Attachment B: Illustration of Recommended Dedications
Right-of-Way Dedications

**Public Works Referral Response
Tentative Planned Unit Development – General Criteria**

Date: 9/17/13
To: Becky Taylor, Planning
From: Ed Haney, Public Works
Subject: PDT13-01 Oakleigh Cohousing PUD

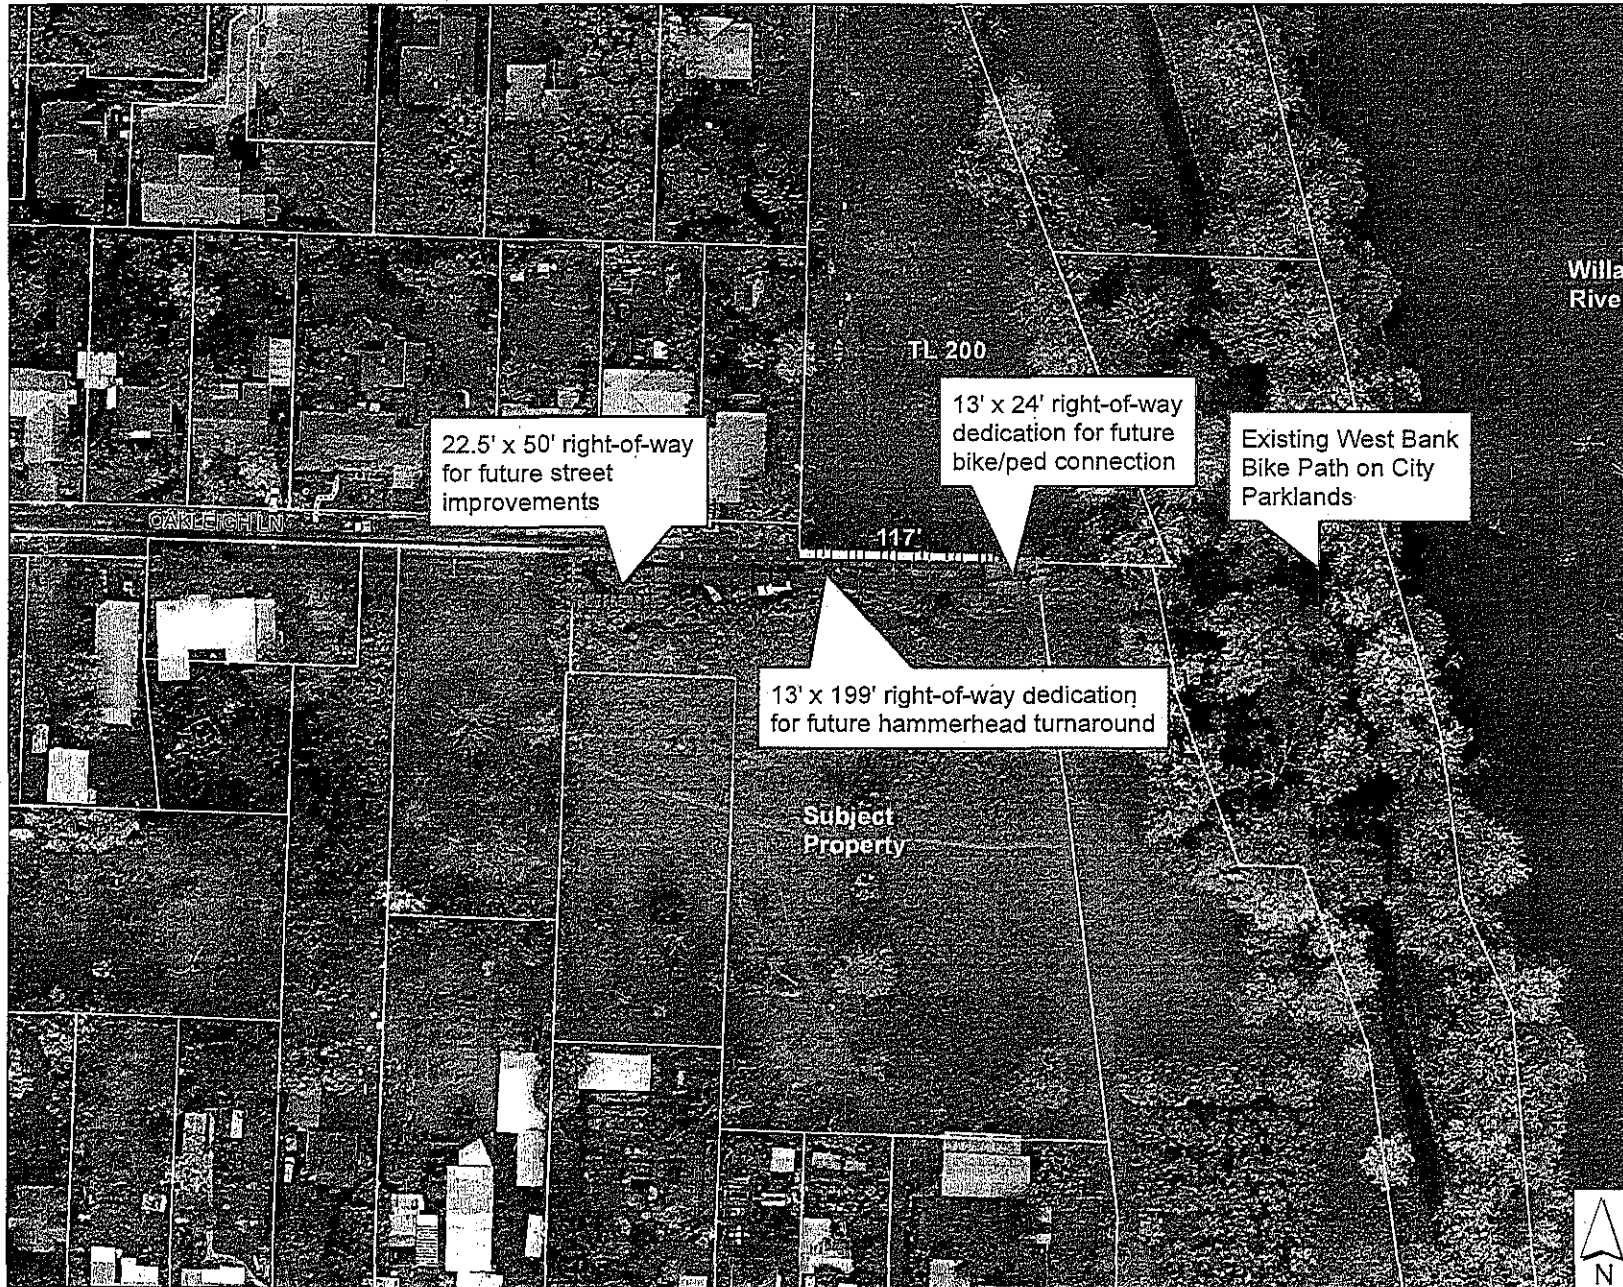
- Prior to final PUD approval, the applicant shall revise the final site plan to show the dedication of 22.5 feet of right-of-way along the northerly boundary of the development, between the westerly boundary of the proposed development and a line that is 50 feet east of the westerly boundary, and also to show the dedication of 13 feet of right-of-way extending from the aforementioned line (the east end of the required 22.5 feet of right-of-way dedication) to a line that is 117 feet beyond (east of) the existing the existing right-of-way (for a total length of 199 feet). Additionally, the revised site plan shall show the dedication of a 13-foot wide Public Accessway along the northerly boundary, which extends from the east end of the aforementioned right-of-way to the easterly property boundary (for a total distance of 24 lineal feet).

There is a nexus between the requirement to dedicate 22.5 feet of right-of-way west of the drive aisle and 13 feet east of the drive aisle and the public interest at issue. The 22.5 feet of right-of-way will result in one-half of the 45 feet of right-of-way which is necessary to construct Oakleigh Lane to the City's minimum street design standards which have been established for a low-volume street. The 13 feet of right-of-way will provide sufficient right-of-way on the south side of the centerline to construct emergency vehicle turnaround with adjacent sidewalks to City standards. Improving Oakleigh Lane to these standards will: allow for two-way vehicular and bicycle traffic; provide separation between vehicular traffic and pedestrians; and provide for emergency response and access to adjacent lots. Because 45 feet of right-of-way is the minimum amount of right-of-way necessary to construct Oakleigh Lane in this manner as a low-volume street, and because 33 feet of right-of-way is the minimum amount of right-of-way necessary to construct the turnaround at this location, the public interest in safe vehicular, pedestrian and bicycle travel and emergency response and access will be at risk if the 22.5 and 13 foot strips of right-of-way are not dedicated.

The requirement to dedicate 22.5 feet of right-of-way from the westerly boundary of the proposed development primary drive aisle and 13 feet from the drive aisle to a line that is 117 feet in length, as measured from east of the existing terminus of the right-of-way is roughly proportional to the impact that the proposed development will have on the City's transportation facilities. The proposed development will result in a 29 new residential units. These residential units will be accessible only from Oakleigh Lane. Currently, 25 lots, consisting of a mix of residential, general office and commercial zoning have structures that take access onto Oakleigh Lane; thus, the additional 29 residential units will increase the number of structures that access this Oakleigh Lane by over 100 percent. The construction of the new (structures will result in an increase of vehicular traffic onto Oakleigh Lane by approximately 164 new vehicular trips per day. See Trip Generation Manual from the Institute of Transportation Engineers (ITE) for Residential Condo / Townhouses (Category 230).

Bicycle/Pedestrian Connections

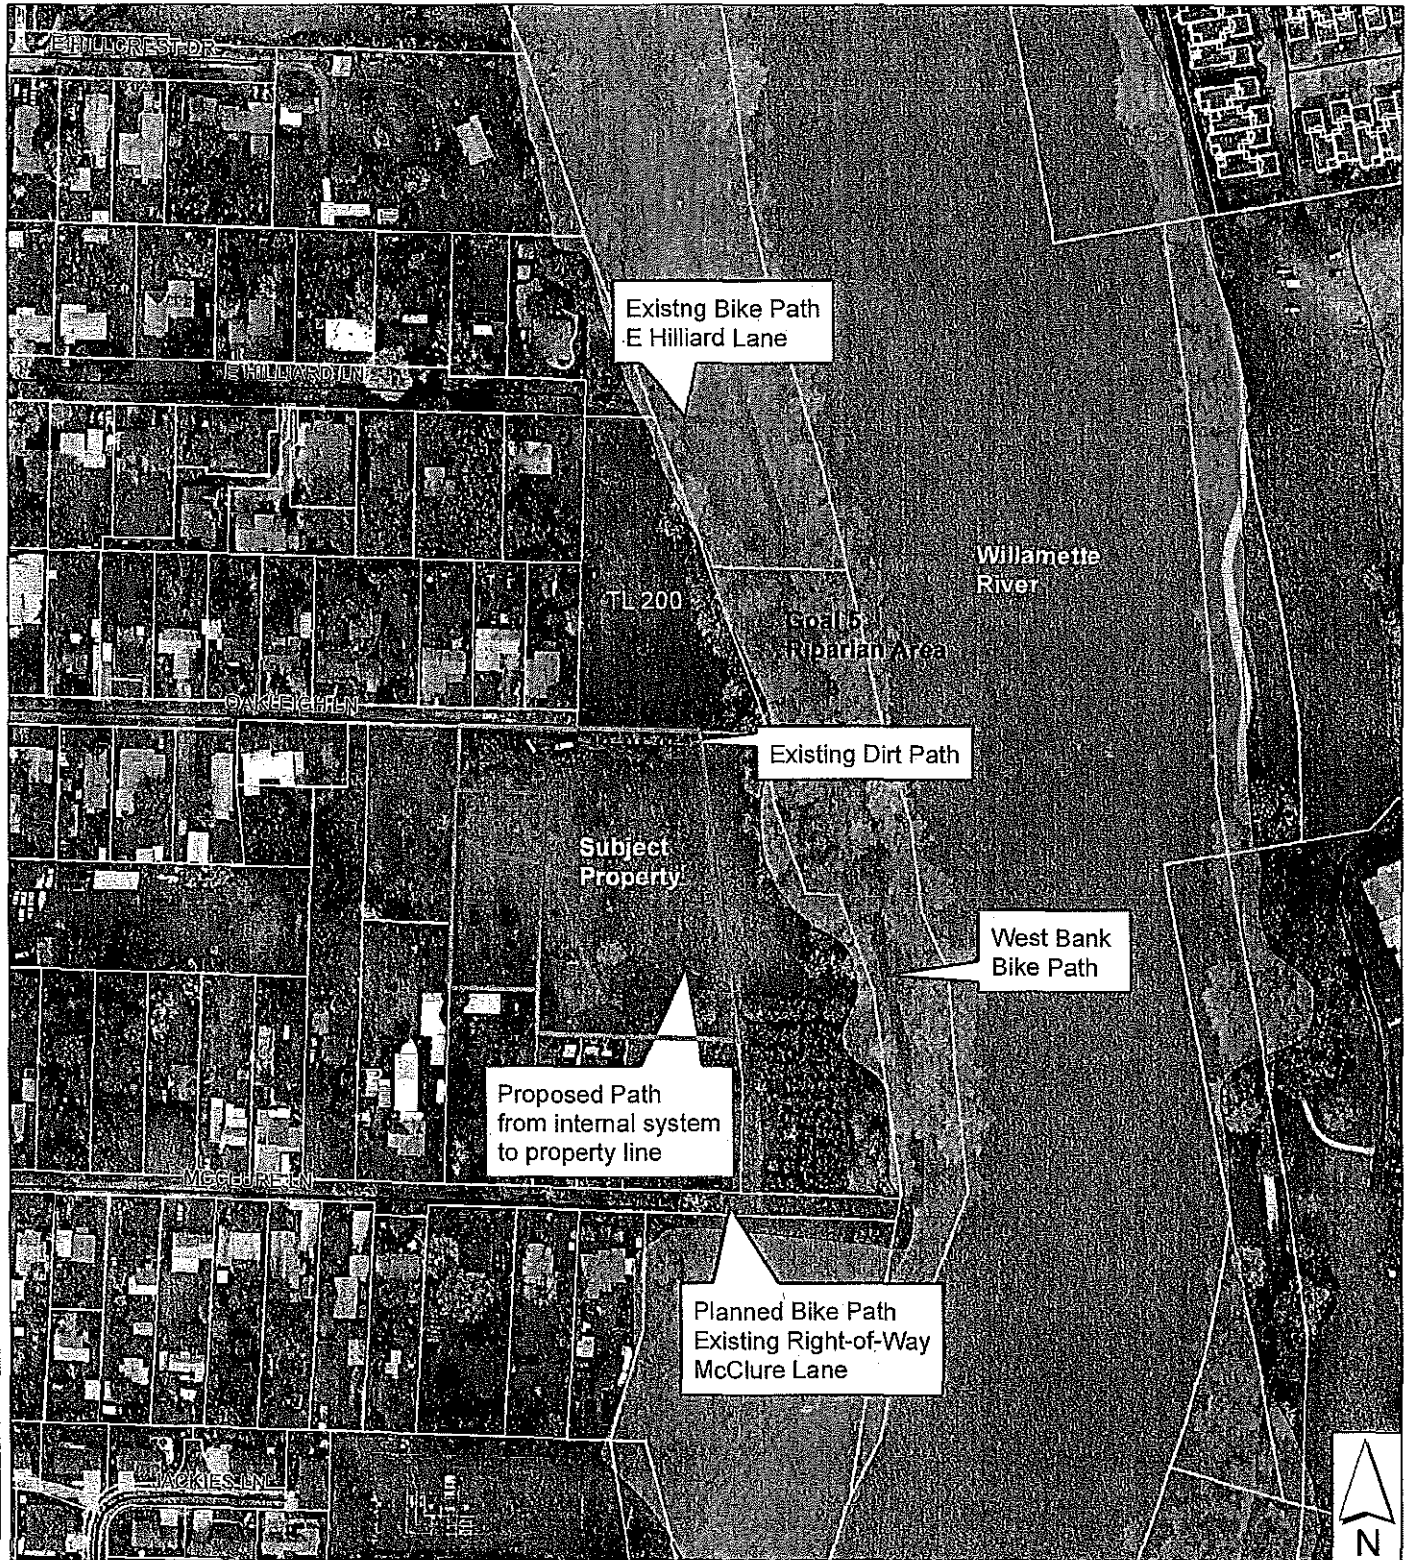
Master Plan identifies a future connector from the east end of McClure Lane to the riverfront path, farther to the south of the subject property. The development proposes an internal sidewalk system that terminates at the southeast property corner, which would enable a future connection through the abutting City parkland to the McClure system to the south. (Refer to Attachment C.)

The segment of the internal sidewalk system that is located between the most easterly building (a bike barn) and the east property line is shown as having a graveled, rather than a paved, surface. This unimproved surface is appropriate because there are no plans or funding for construction of a public path on the City property at this location. Residents of the development will naturally want to walk across the City parkland toward the river. Parks staff state no objections or concerns. This proposed path at least delineates a more confined direction of travel, rather than random wandering through the City's resource area. This portion of the City property has been cultivated as a filbert orchard, which has been maintained by the former owner of the subject property, as discussed in the applicant's written statement. There appears to be an informal path between the orchard and the subject property that would direct travelers to the southerly McClure Lane right-of-way. Public Works staff confirms that the planned bicycle and pedestrian connection through the City's parkland is from McClure Lane toward the easterly West Bank Bike Path, which is a regional facility that borders the west bank of the Willamette River.

The applicant's plans also show an informal path, along the north property line, from the existing end of Oakleigh Lane to the riverfront path system. On page 31 of the written statement, the applicant indicates that the path "will be improved and maintained by Oakleigh Meadow, LLC." The applicant does not propose to improve the path with pavement, but rather to keep its current conditions open to the public. The right-of-way dedication being required for Oakleigh Lane covers most of this informal path. Between this right-of-way and the east property line (24 lineal feet), a 13-foot wide public access way is necessary to provide for a future bike path connection from the approved turnaround and sidewalk in the direction of the West Bank Bike Path.

Attachment D-2 Site Plan

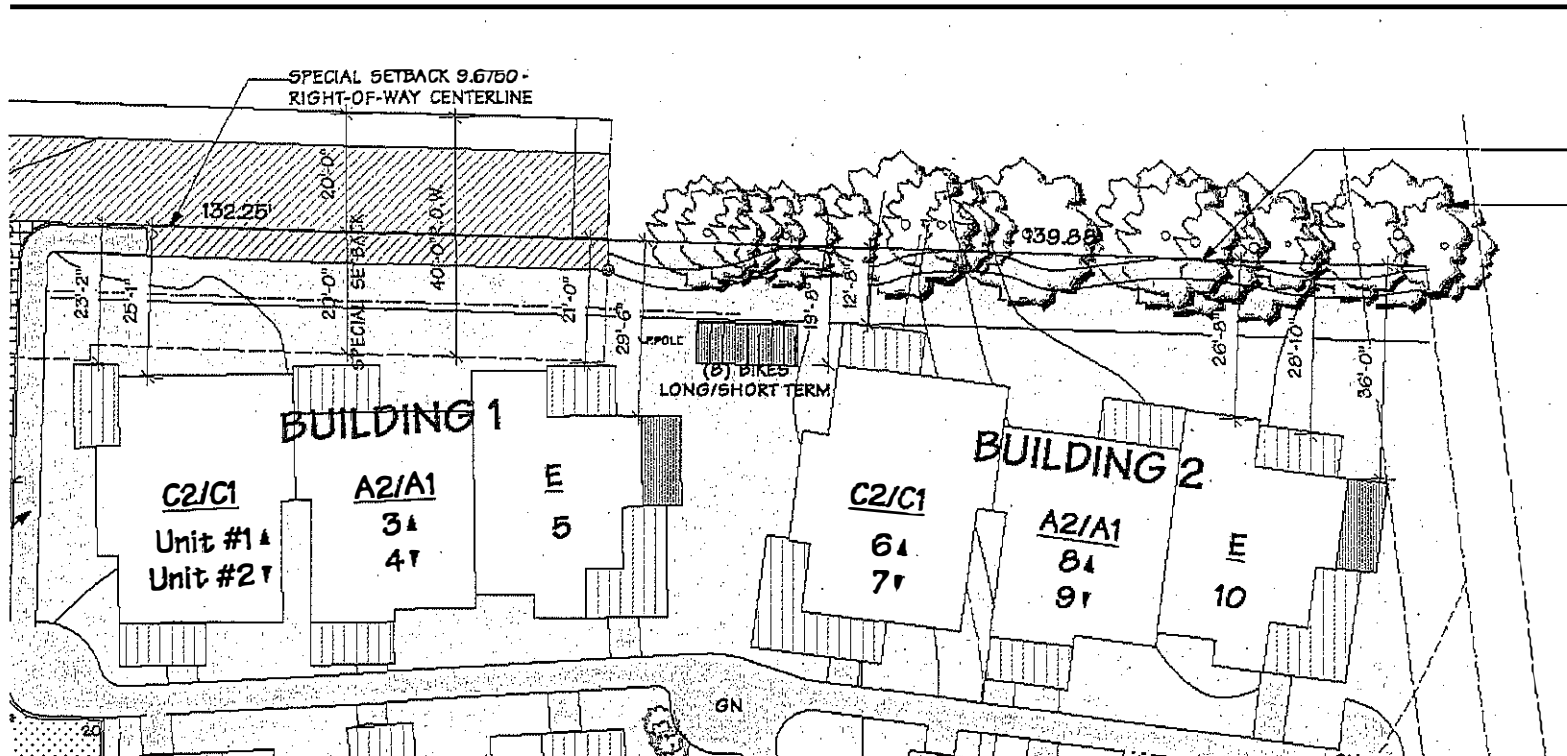
With regard to EC 9.6410 Motor Vehicle Parking Standards, the applicant's plans show 16 covered spaces, as garages and carports along the west property line. The applicant's plans note that there are 31 additional open/surface parking spaces. The plans show approximately 29 gravel parking spaces abutting the paved driveway. The minimum number of vehicle parking spaces required is one per dwelling unit (or 29 in this case). It appears that the minimum requirement is met; there is no limitation on the maximum number of vehicle parking spaces for residential development. The actual number of spaces is difficult to determine because the applicant does not propose to stripe the spaces in accordance with the stall dimension standards of EC 9.6410; however, the scaled plans show sufficient areas to accommodate the required parking. Public Works staff notes that, due to the 22-foot wide drive aisle, all of the parking spaces are considered compact.

The applicant seeks a modification to the striping, surfacing, and landscaping requirements for the vehicle parking spaces. EC 9.6410 requires a durable and dust-free surface, whereas the applicant proposes gravel parking spaces. The applicant proposes filter fabric below the gravel surface to meet the durable and dust-free standard. The applicant also explains that the driveway will be paved, where durability and dust would be of greater concern associated with vehicle movements. To keep gravel in the parking stalls and off the driveway, the applicant states that the planned community can maintain this area and suggests keeping a broom nearby. The abutting concrete wall proposed along the west property line serves as mitigation to additional noise and dust associated with gravel.

- Prior to final site review approval, Sheet A1.1 shall be revised to show striping for each parking space and to designate each parking space as "compact".

Attachment D-3 North Line Setback Detail

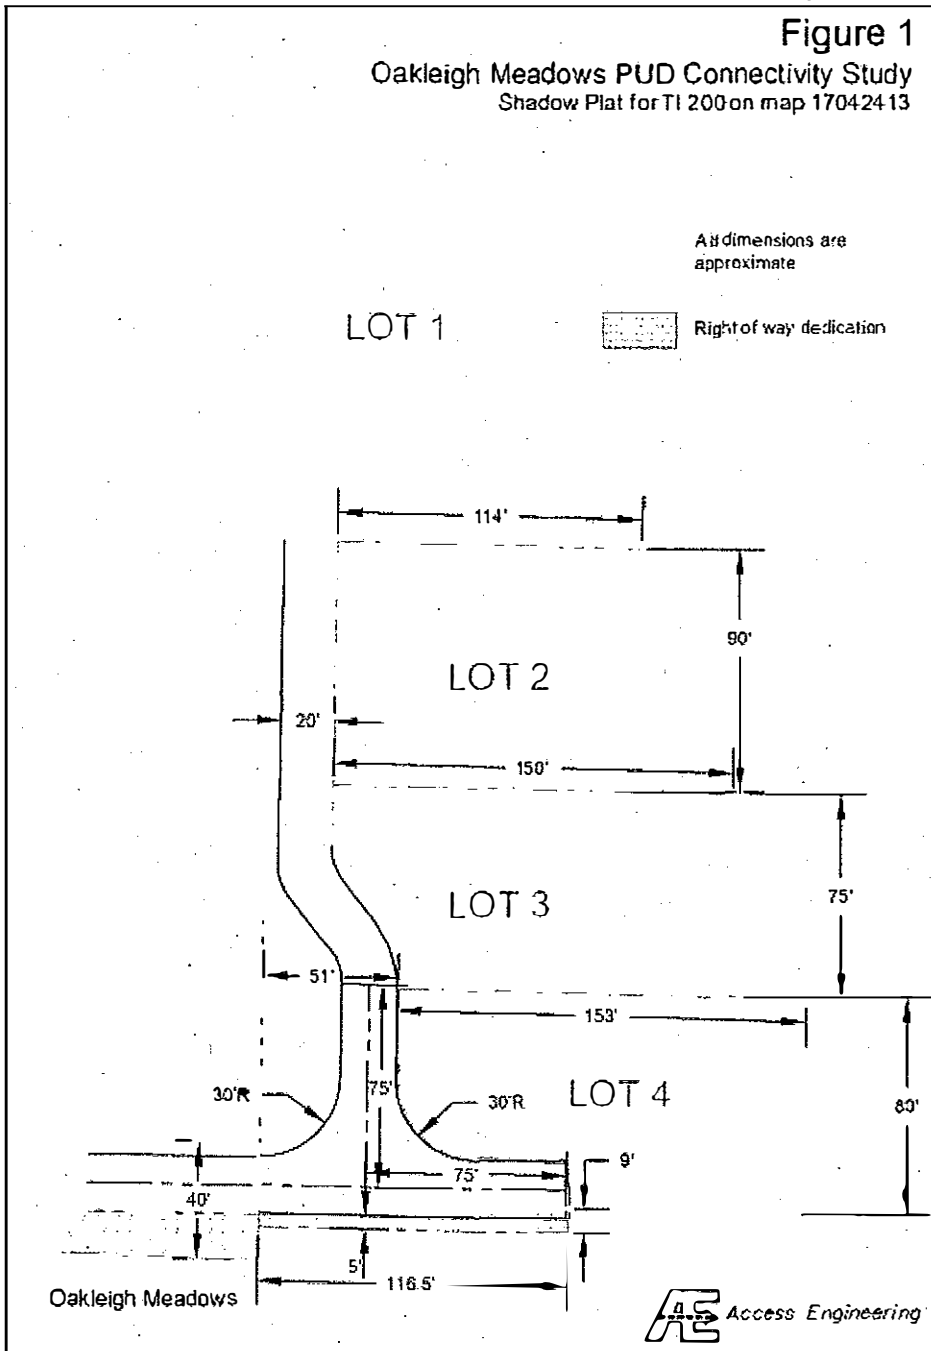
to the findings and conditions at EC 9.8320(5), which are incorporated by reference. Following right-of-way dedication, Buildings 1 and 2 will be below the minimum 10-foot front yard setback requirement, being about a half of a foot and eight feet away, respectively. The applicant requests a modification to this setback, stating that "...the dwellings abutting Oakleigh Lane do not exceed massing widths or heights inconsistent with the neighborhood single-family proportions. Along Oakleigh Lane, at the southern side of the street, townhouses address the residential street with covered porches as found in this and other neighborhoods of the River Road area. Internally, the site plan is pedestrian oriented with many places for children to play and residents to sit outside. By clustering the units keeping all the parking to one side of the site, more usable open space, free from vehicle traffic, was able to be conserved with open views to the river and bike path." (See page 26 of the applicant's June 14, 2013 written statement.)

With regard to 9.2795 Solar Setback Standards, EC 9.2795(3) grants an exception to these standards because the buildings abutting the north property line (Buildings 1 and 2) would shade a non-developable area, namely right-of-way for Oakleigh Lane and the bicycle/pedestrian access way required along the north property line. For comparative purposes, absent the right-of-way, the required solar setback would be 20 feet from the north property line. Both buildings are setback at least 20 feet from the north property line. As such, it does not appear that a formal modification through the PUD process is required; however, one could be supported for the same reasons a modified front line setback, as discussed previously, would be granted.
